November 24, 2021

Subject: North Shoreview Elementary School HVAC Replacement
San Mateo - Foster City School District
Aedis Project No. 2021005.05
DSA Application #01-119554

ADDENDUM NO. 1

1 ELECTRICAL NEW FLOOR PLAN - BLDG A

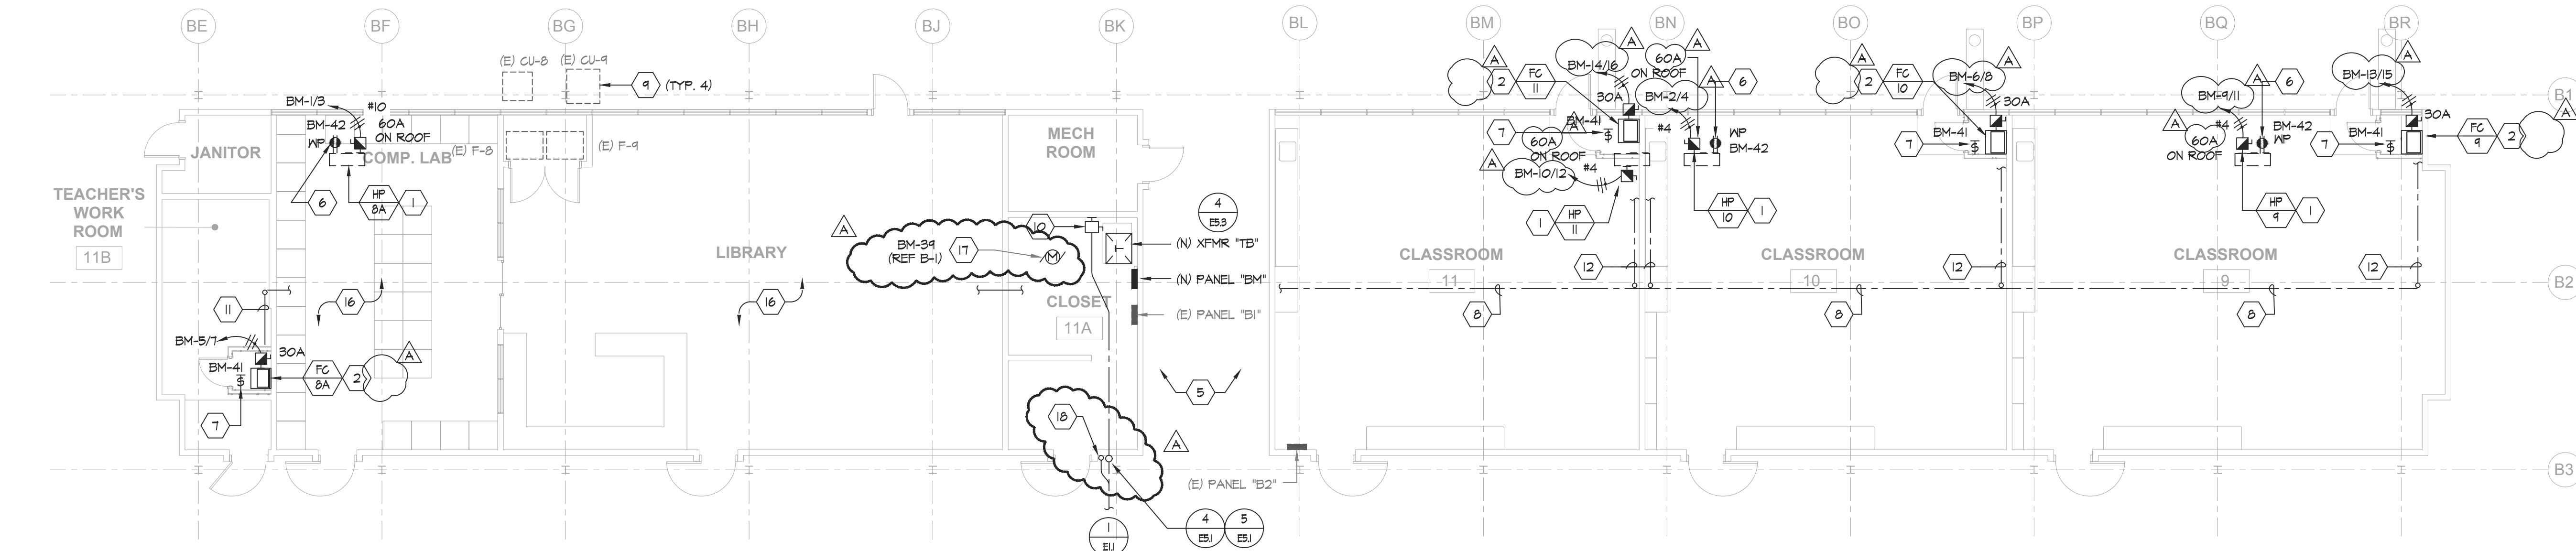
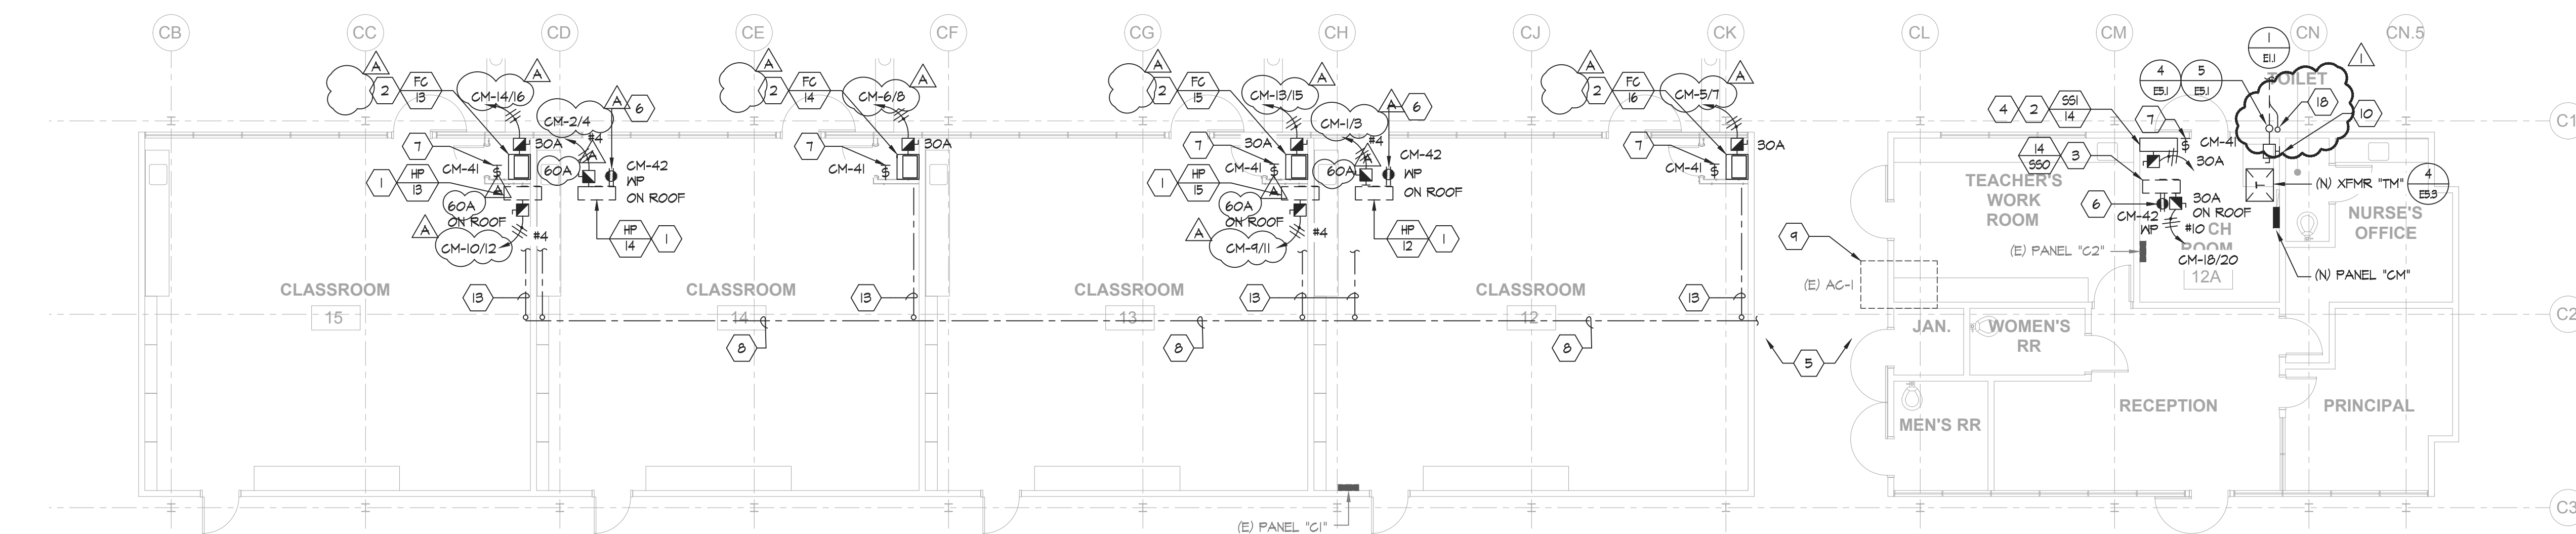
Add: General Note #7 per AD1-E3.1.
Add: Sheet Note #17 and #18 per AD1-E3.1.
Add: Power for exhaust fan at building per AD1-E3.1.
Revise: Sheet Notes #1 and #2 per AD1-E3.1.
Revise: Power plans per AD1-E3.1.

1. PROVIDE CONDUIT ROOF PENETRATIONS REQUIRED. COORDINATE ROOF PENETRATION LOCATIONS WITH MECHANICAL'S PIPING ROOF PENETRATIONS. ROOF PENETRATION SHALL BE PER DETAIL 4/MP6.01.

ELECTRICAL NEW FLOOR PLAN - BLDG D

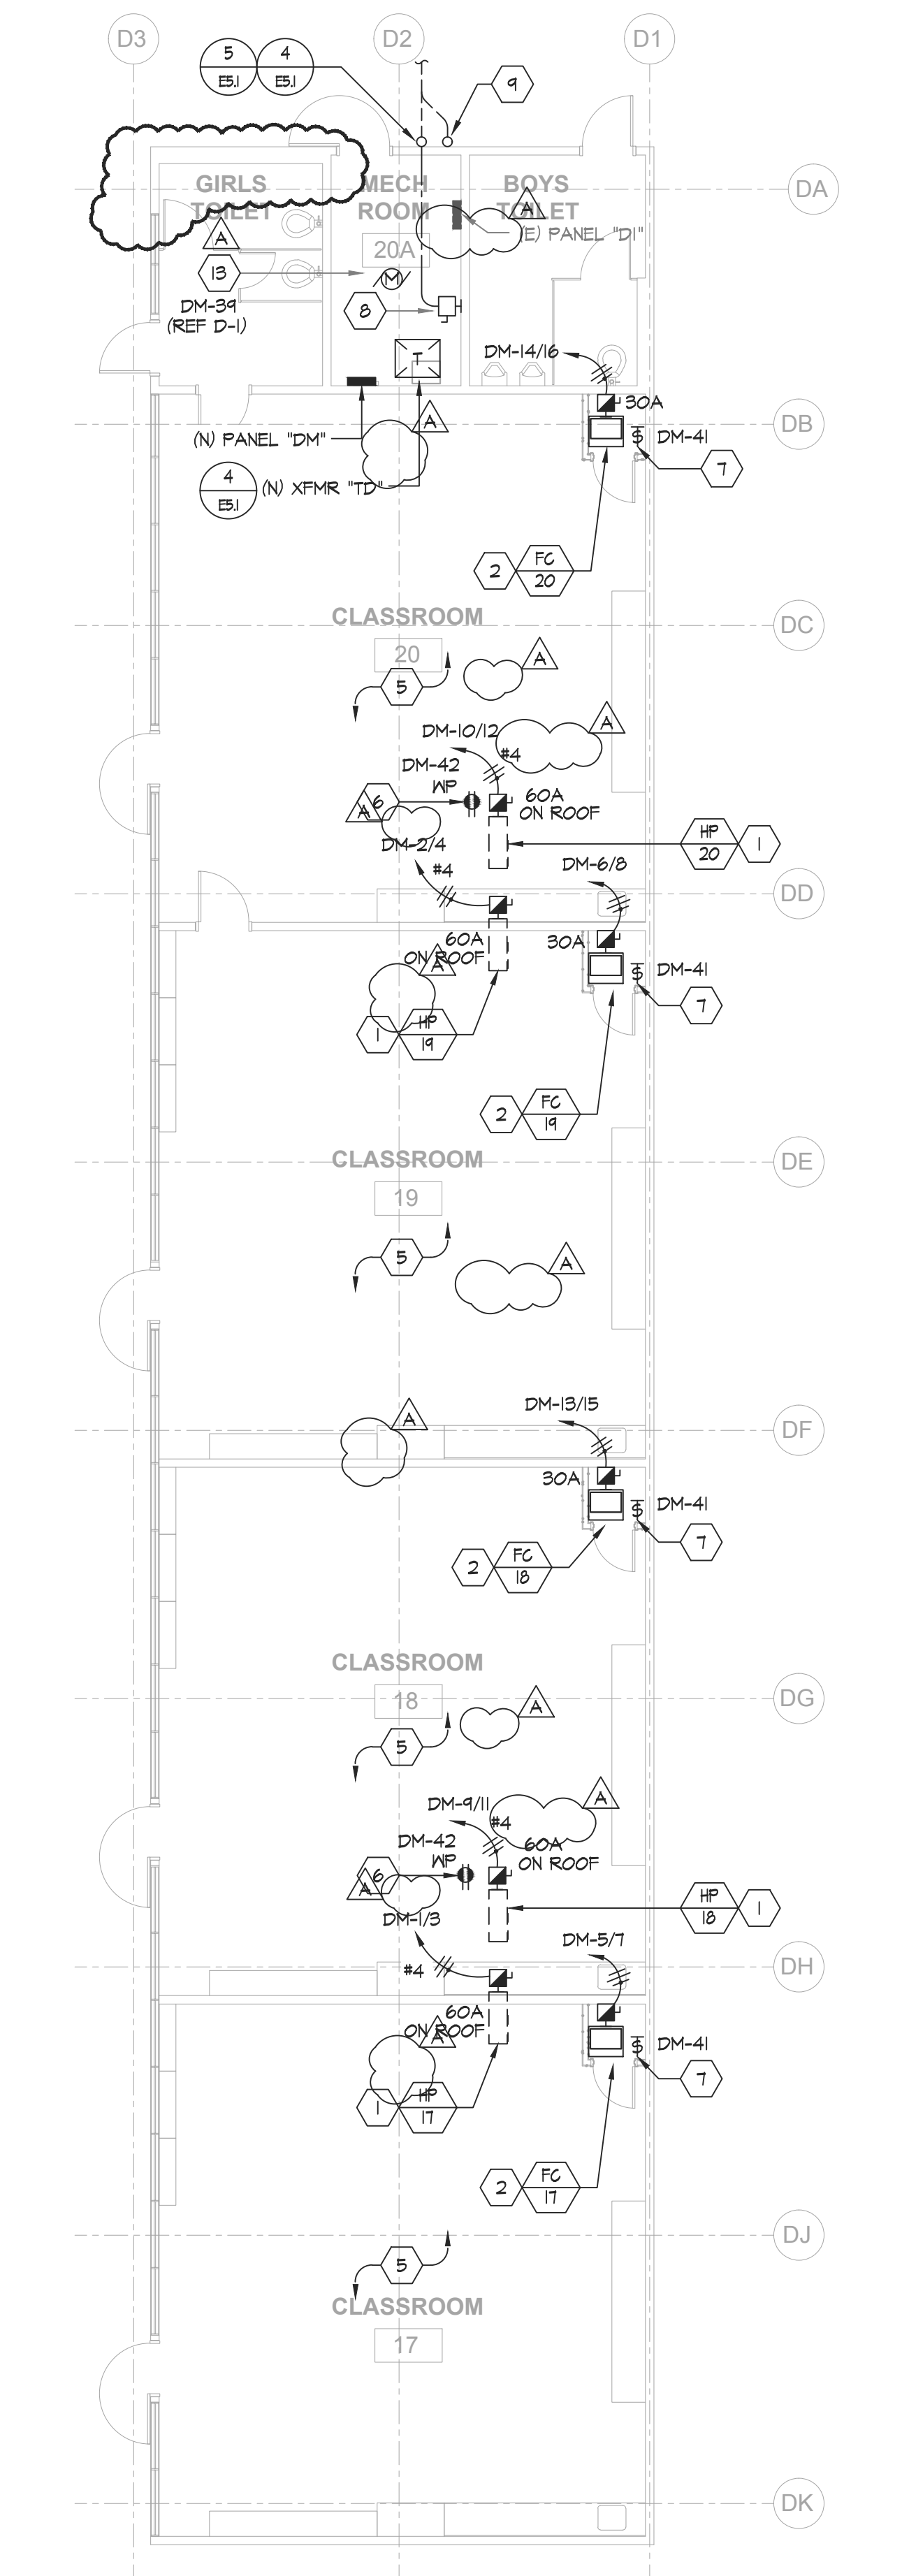
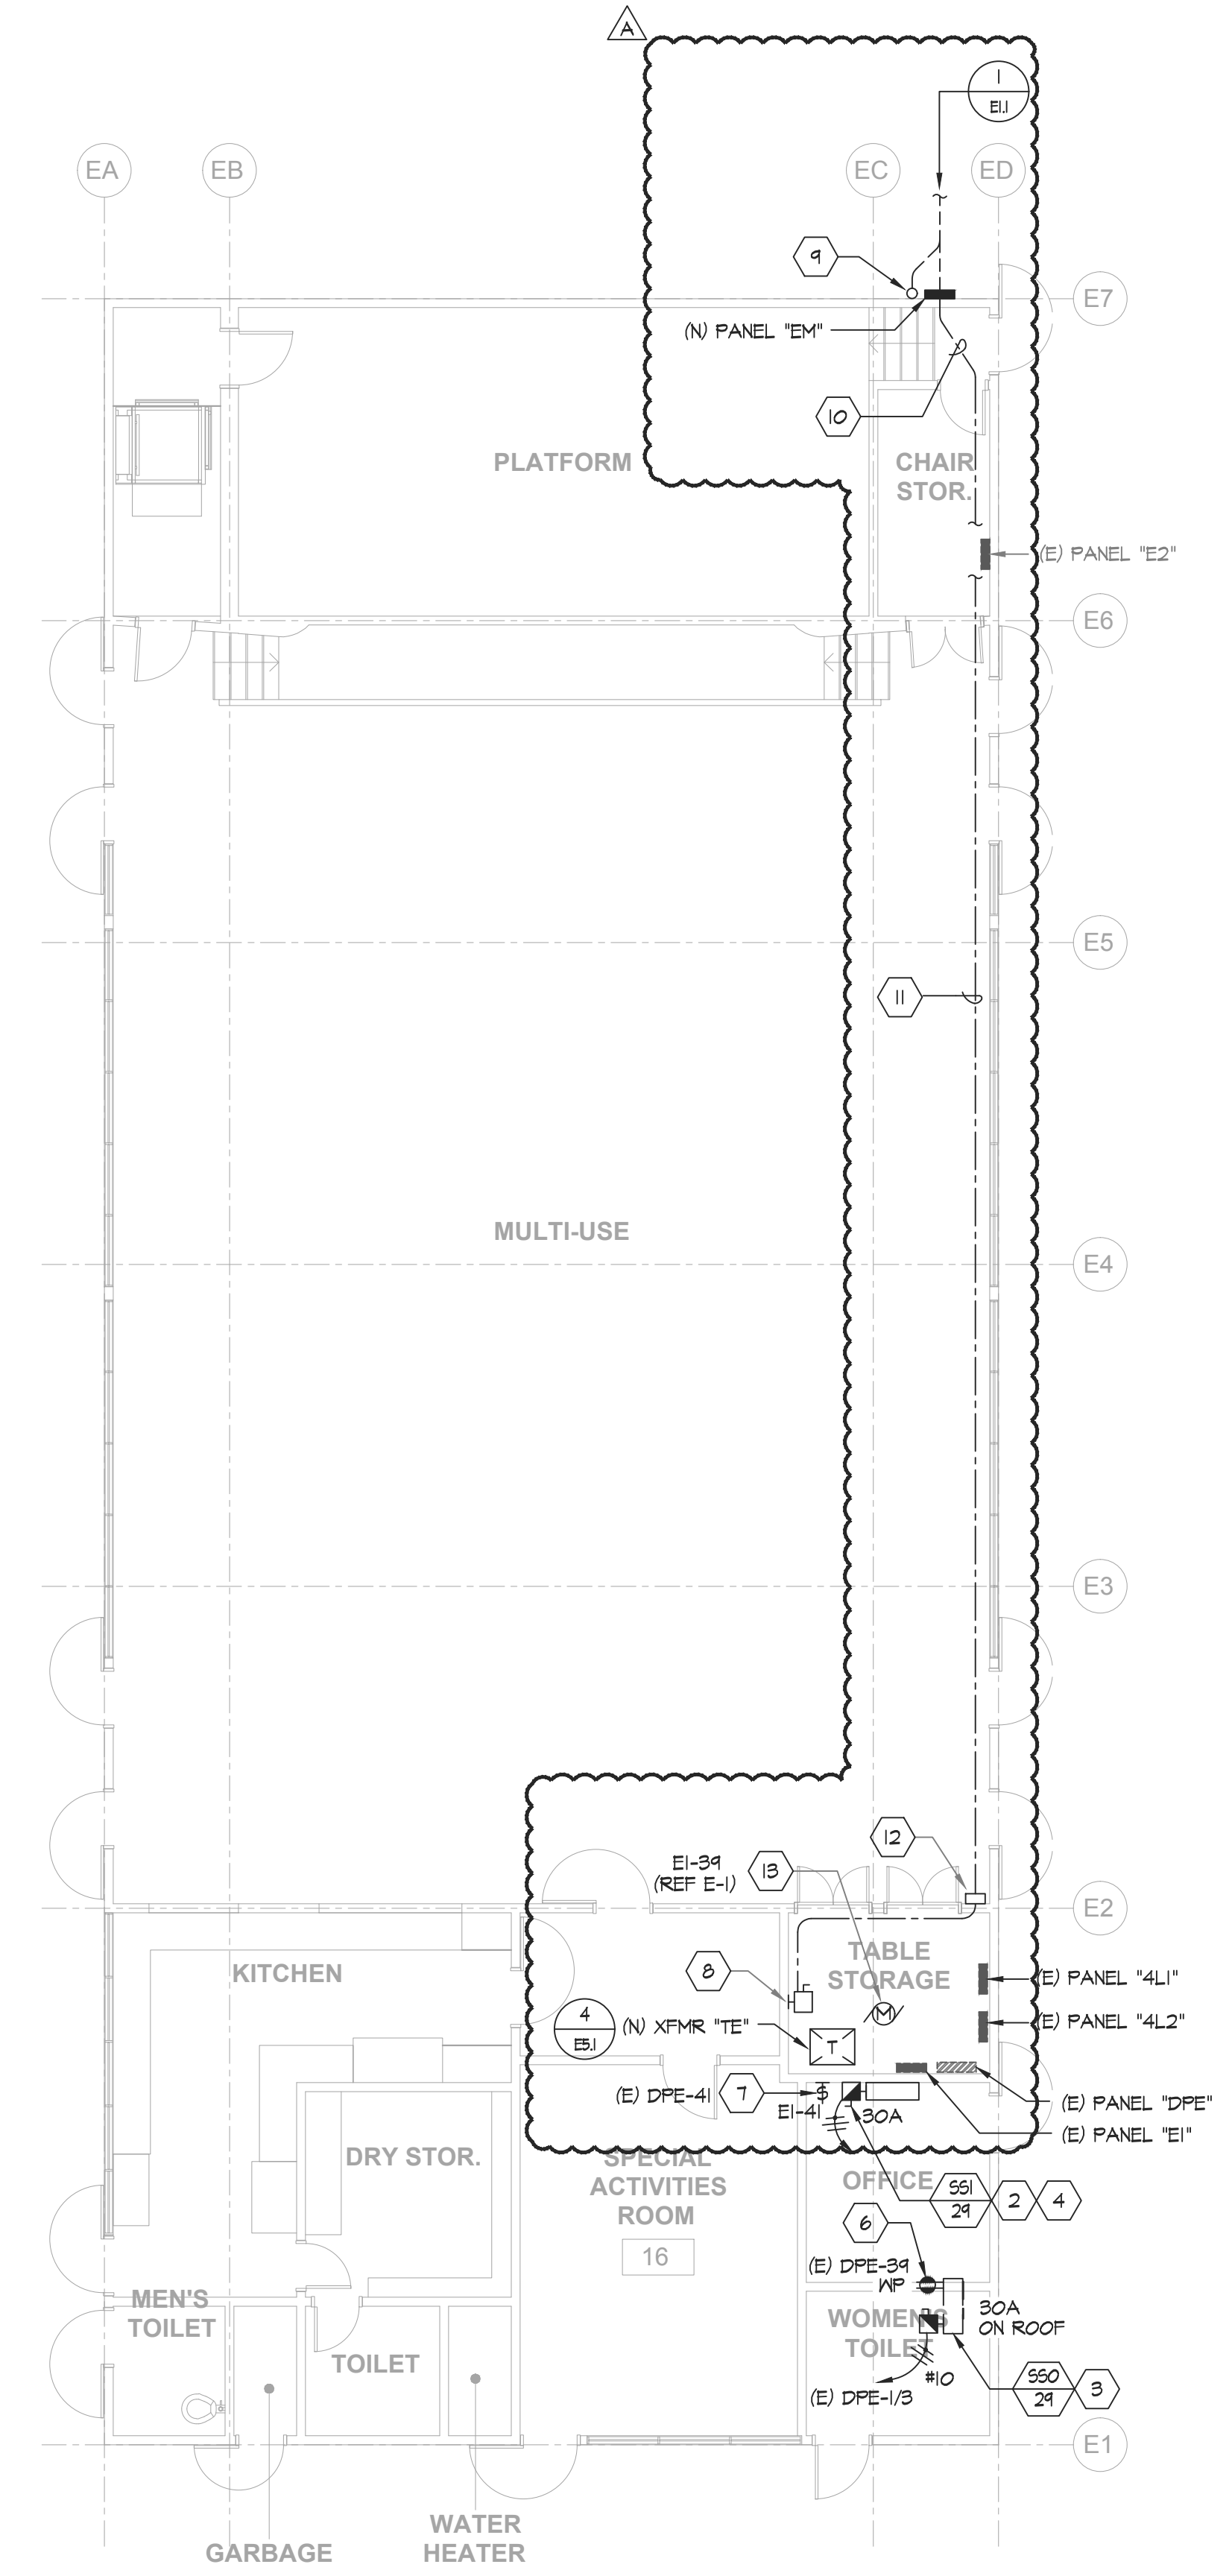
Add: General Note #7 per AD1-E3.2.
Add: Sheet Note #10, #11, #12 and #13 per AD1-E3.2.
Add: Power for exhaust fan at building per AD1-E3.2.
Add: Conduit routing in Multi-Use building per AD1-E3.2.
Revise: Power plans per AD1-E3.2.
Revise: Sheet notes #1 and #2 per AD1-E3.1.

7. PROVIDE CONDUIT ROOF PENETRATIONS REQUIRED. COORDINATE ROOF PENETRATION LOCATIONS WITH MECHANICAL'S PIPING ROOF PENETRATIONS. ROOF PENETRATION SHALL BE PER DETAIL 4/MP6.01.
